January 04, 2017

37K4 UPDATE - DSG Software Update (FED\_EMS) - U.S. ONLY

### **Production Solution**

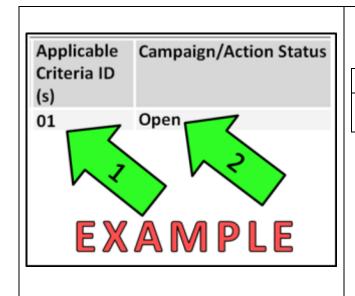
On vehicles with a 6 speed dual clutch gearbox, malfunctions can occur when using the cruise control system because of a programming error. When activating the cruise control system, the gearbox can change shift into too low a gear.

Improved DSG software.
